Responses to Comments of Reviewer #1

Localisation for Malanville based on adaptive distance (semi-variogram) (Niger Basin)

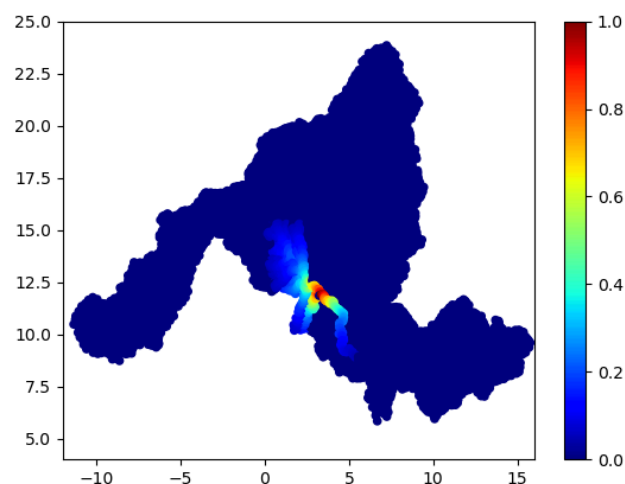
6. The hashed effect observed in the assimilated products seems to result from the sparseness of observations and the use of observation localization. From the description in Lines 504–512 and Figure 17, it is unclear whether all observations within the 'local patch' (as shown in Figure 7) are utilized. It would be valuable to investigate how many observations can be accommodated within a single local patch. If the local patch is large enough to include a substantial number of observations, the hashed effect could be minimized. Therefore, the authors are encouraged to analyze the effect of local patch size and the number of observations within each patch to determine their impact on the results.

When developing our methodology, we conducted exploratory tests in the Niger basin using MGB-HYFAA with three localization strategies: no localization, constant-distance localization (300 km), and adaptive localization based on semi-variograms computed for each pixel. Adaptive localization generally reduced the hashed effect compared to the other approaches by better accounting for hydrological connectivity (as explained previously), but the hashed effect remains present after each assimilation in stations where there is a big misalignment between simulated and observed rating curves and where these WSE are available and assimilated.
